Access Compliance Report

Public Rights-of-Way

Intersection ID: 53493	Main Street: PROVIDENCE_COUNTRY_CLUB_DR	Cross Street: MCGILL_HEIGHTS_RD	Location: SE
ADA ID: FE75BE1A096E	Ramp Type: Perp	Initial Pass/Fail: Fail	Overall Compliance: No
			Severity Score: 12.5

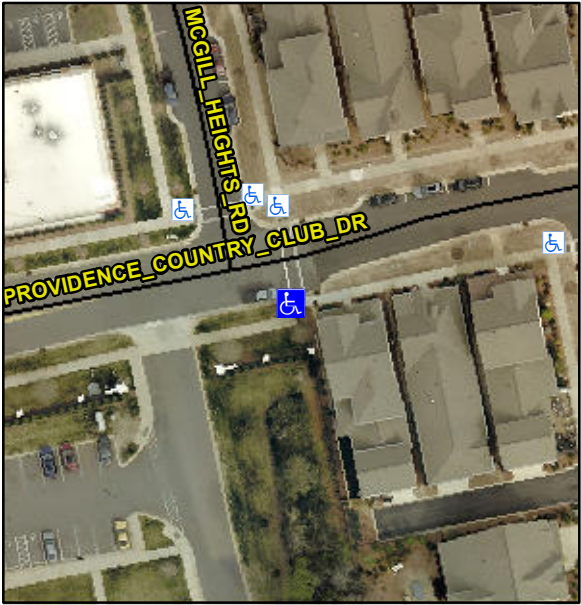
Codes/Mitigation Info/Possible Solution			Field Measurements/Component Compliance		
	Possible Solutions:		Compliance	Description	Data
	Remove & Replace Entire Ramp.		N/A	Ramp Length (in)	67.0
			Yes	Ramp Width (in)	79.0
			N/A	Flare Type LT	N/A
			N/A	Flare Slope LT (%)	N/A
			N/A	Flare Traversable LT?	N/A
			N/A	Landing Length (in)	N/A
			N/A	Landing Width (in)	N/A
			N/A	Landing Slope (%)	N/A
			N/A	Landing X Slope (%)	N/A
<p>Surveyor Notes:</p> <p>N/A</p> <p>PROW/ADA:</p> <p>R304.5.3</p>			N/A	Flare Type RT	N/A
			N/A	Flare Slope RT (%)	N/A
			N/A	Flare Traversable RT?	N/A
			N/A	DWS Provided?	N/A
			N/A	DWS Contrast?	N/A
			N/A	DWS Length (in)	N/A
			N/A	DWS Full Width?	N/A
			N/A	DWS Offset (in)	N/A
			N/A	Gutter Ponding?	N/A
			N/A	Gutter Lip Ht (in)	N/A
			N/A	Painted X Walk1?	No
				X Walk 1 Direction	To N
			N/A	X Walk 1 Width (in)	N/A
				X Walk 1 Slope (%)	1.5
				X Walk 1 X Slope (%)	1.5
			N/A	Ramp inside XWalk1?	N/A
